Brownfields Cleanup Request for Bids Questions and Answers
Caribou Diesel Electric Power Plant and Associated Outbuildings
142 Lower Lyndon Street, Caribou, Maine

ENLARGED PLAN OF DEVELOPED AREA

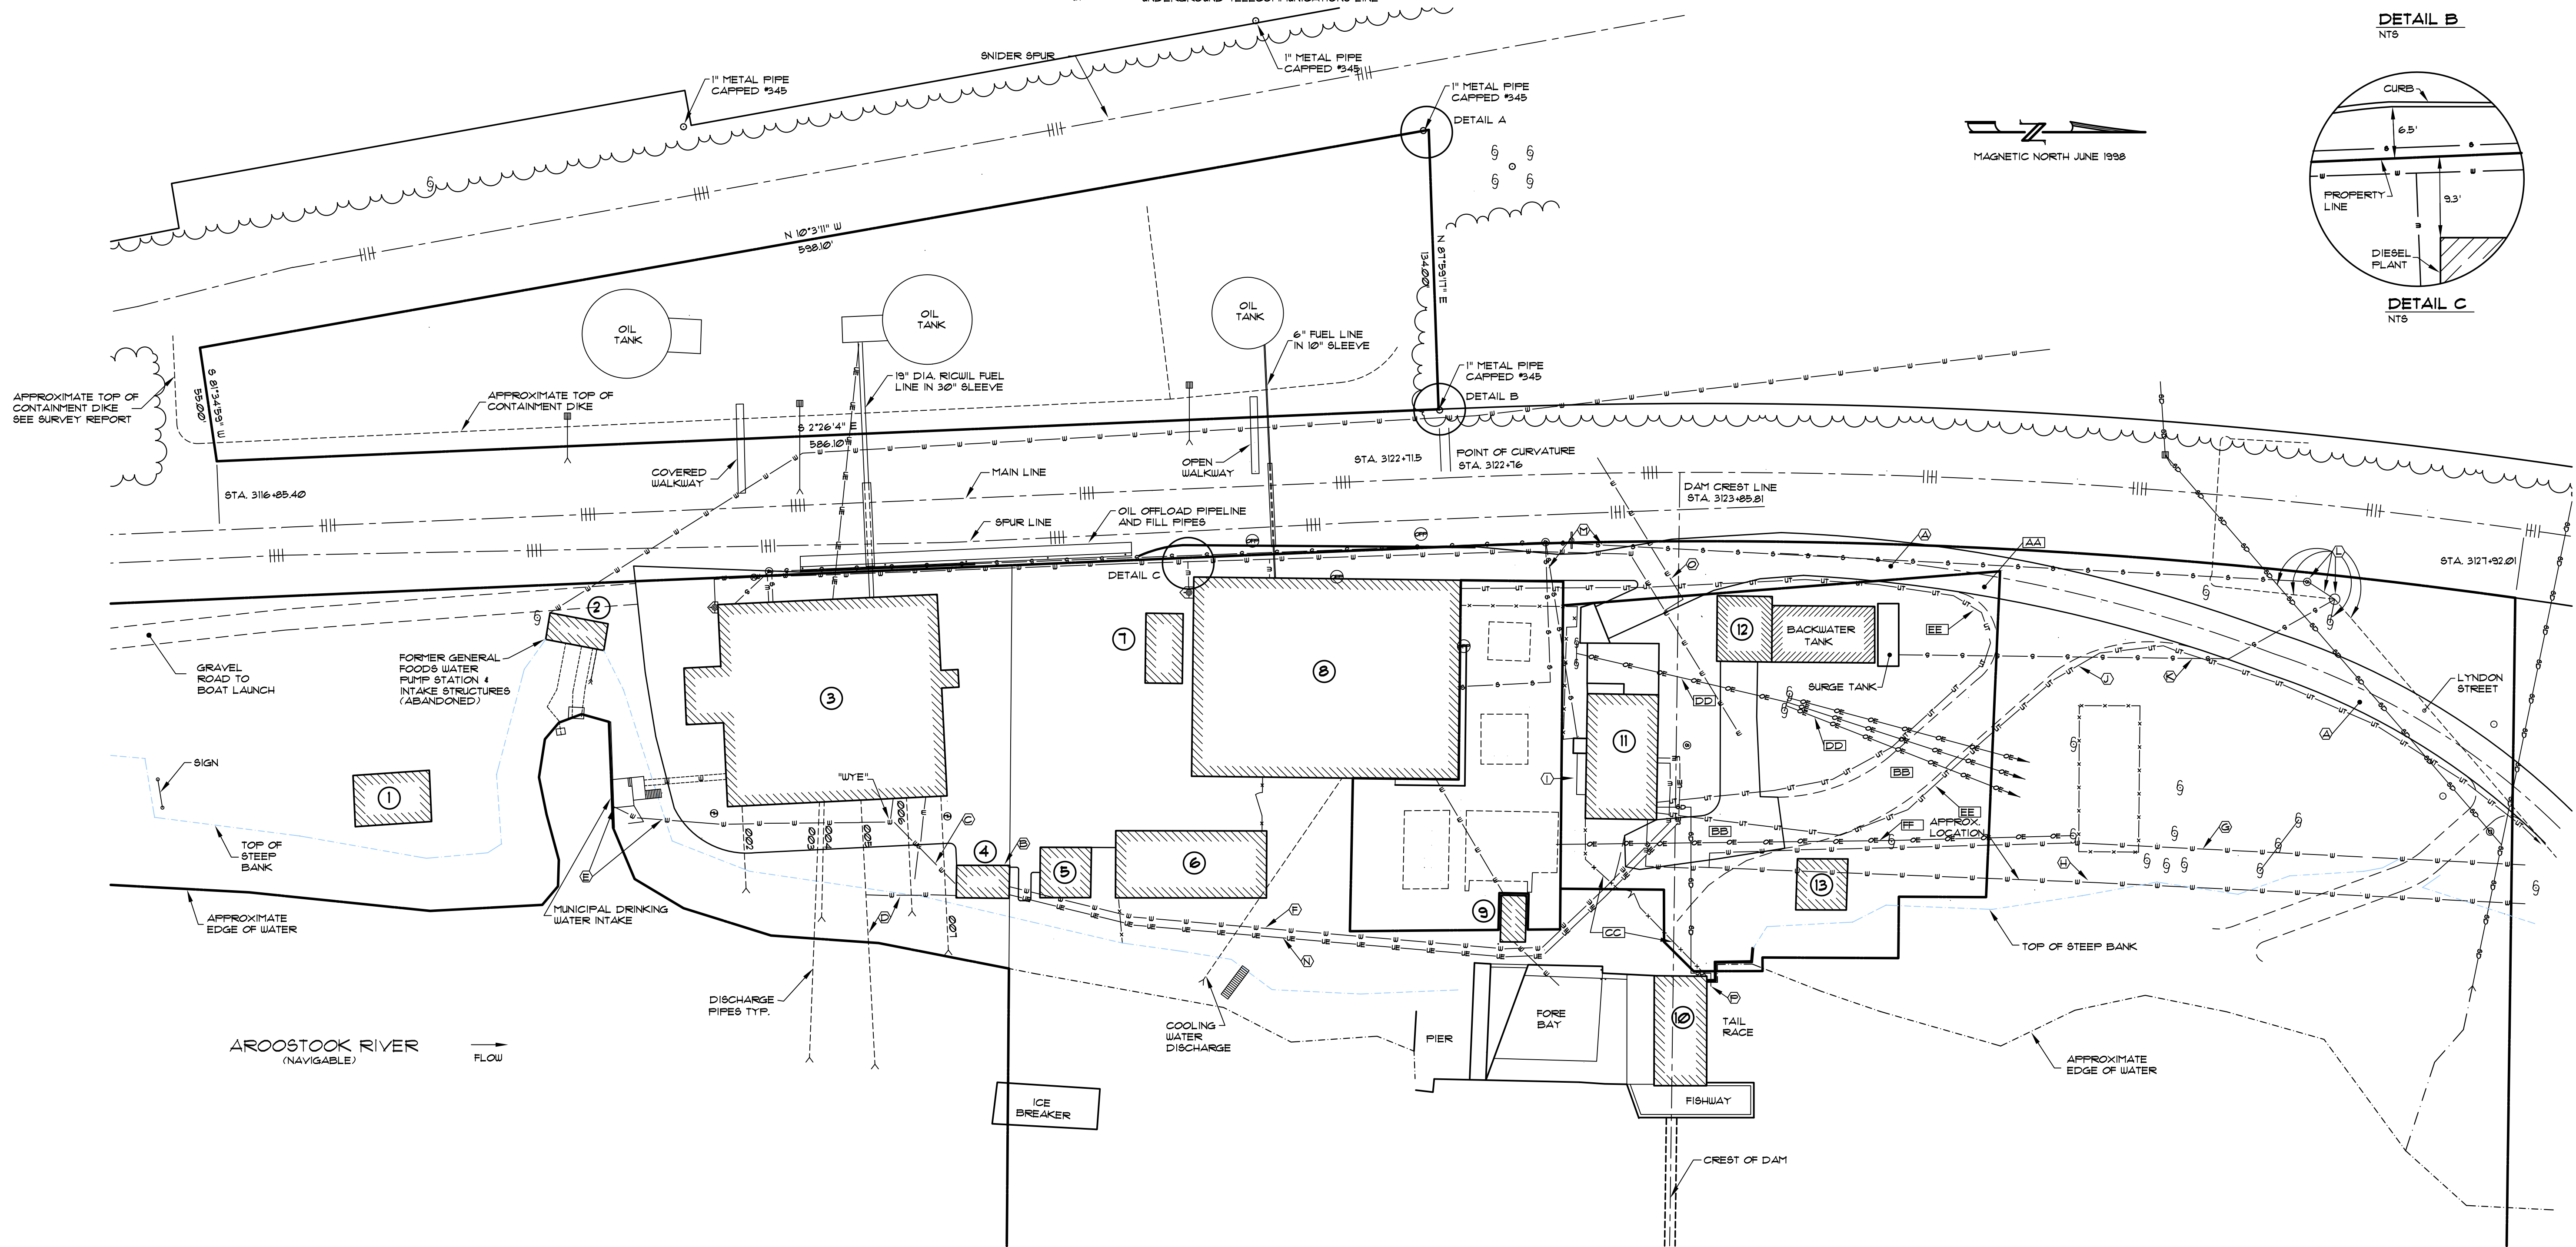
OUTFALLS: How will we cap the large openings that go down to the river?

All municipal water, municipal sewer, cooling water supply, cooling water discharge, and outfall drainage piping at the diesel plant and diesel pump house will need to be properly capped and secured prior to building demolition. Refer to the attached outfall summary and boundary survey for known municipal water, municipal sewer, electrical, cooling water piping, and outfalls. The City of Caribou will rely on the selected contractor to properly cap and secure all utility connections in accordance with local, state and federal regulations and industry-accepted methods. The capped municipal water and sewer lines shall be inspected by the Caribou Utilities District prior to backfill.
